OXFORDSHIRE COUNTY COUNCIL'S RESPONSE TO CONSULTATION ON THE FOLLOWING DEVELOPMENT PROPOSAL

Application no: 21/02339/REM

Proposal: Reserved Matters application for 14/02121/OUT, Phase 1 Development of 500 dwellings, landscaping, new vehicular, cycle and pedestrian access routes and other operations

Location: Proposed Himley Village North West Bicester, Middleton Stoney Road, Bicester

Access and circulation

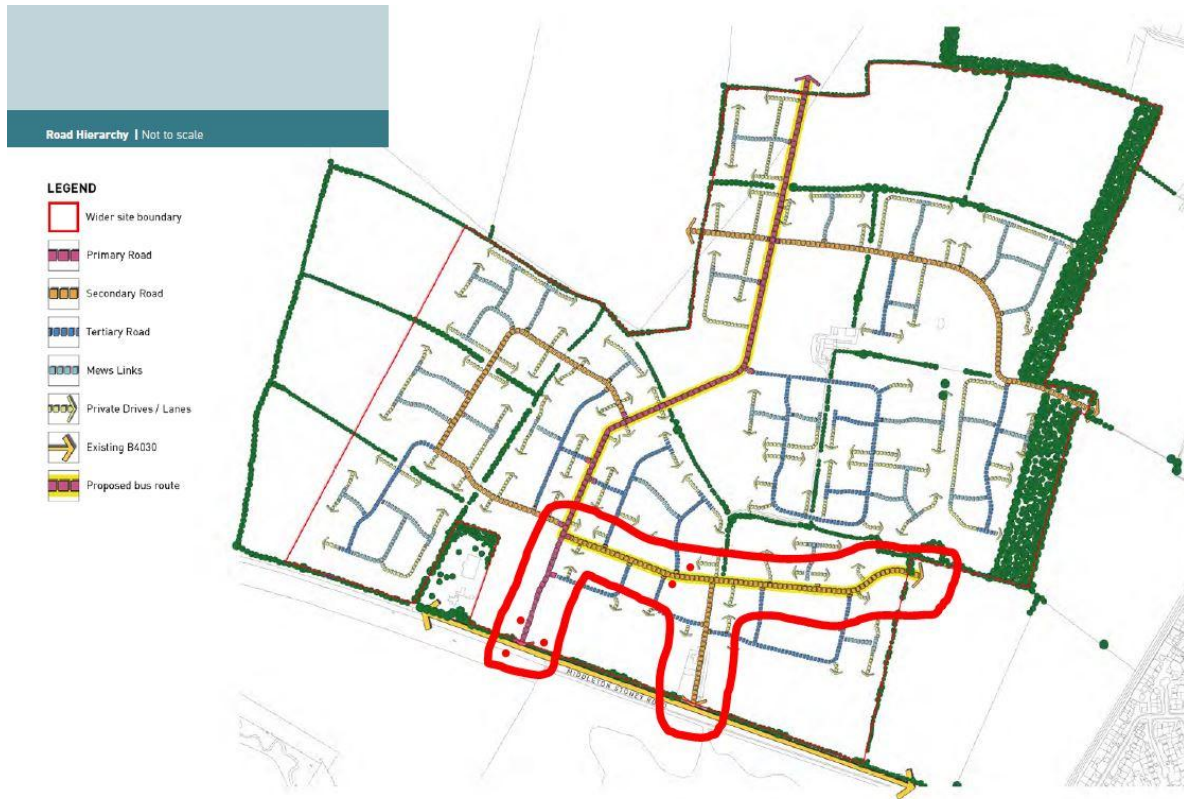
As part of Phase 1 further bus stops are expected to be delivered on Middleton Stoney Road and on the development itself, which could facilitate the diversion of services into this Phase and avoid the need for a dedicated service in the short to medium term.

Given the prevailing context of development in the area, Himley can be expected to act as a standalone new settlement close to but outside Bicester for a significant period of time. It is therefore imperative that an initial bus route can penetrate into the Phase 1 development at an early stage. Therefore the roads indicated in the above diagram (circled with red lines) must be to Primary standards, not Secondary, as two-way bus operation will almost certainly be required on these streets for a significant period. (from p109 of Design Code).

Access points to/from Middleton Stoney Road, and on-site junctions to be used by bus, must be suitable for full size single deck buses (up to 12.2m in length) to make suitable turns.

It is noted that no provision is made for off-carriageway parking in bays along the Primary Street. A continuous frontage is proposed, without individual vehicular access from the Primary Street. Experience with this shows that these arrangements set up particular pressure to use the carriageway for parking, including for delivery vans, all of which tends to seriously impede the progress of buses. As far as possible a clear carriageway should be provided on all roads intended to act as bus routes. The optimum way to balance these requirements would be through the provision of off-carriageway bays. The alternative, which is less desirable albeit reasonably effective, would be the use of enforceable parking restrictions, such as double yellow lines, that allowed for loading.

Without high levels of bus productivity, it is impossible to provide a high level of service in developments such as this as buses take too long to navigate through the development.

Whilst the bus service pattern envisaged in the Eco Town Master Plan (with both north and south routes utilising Bucknell Road) is not now considered the most appropriate means of serving the sites by bus, highway connections to adjoining land holdings forming part of the Eco Town are necessary for the final intended pattern of bus access and circulation in the future. The link between the Primary Street to the boundary with Albion, referred to as a Secondary Street within the Design Code, is as important in this regard as the Primary Street.
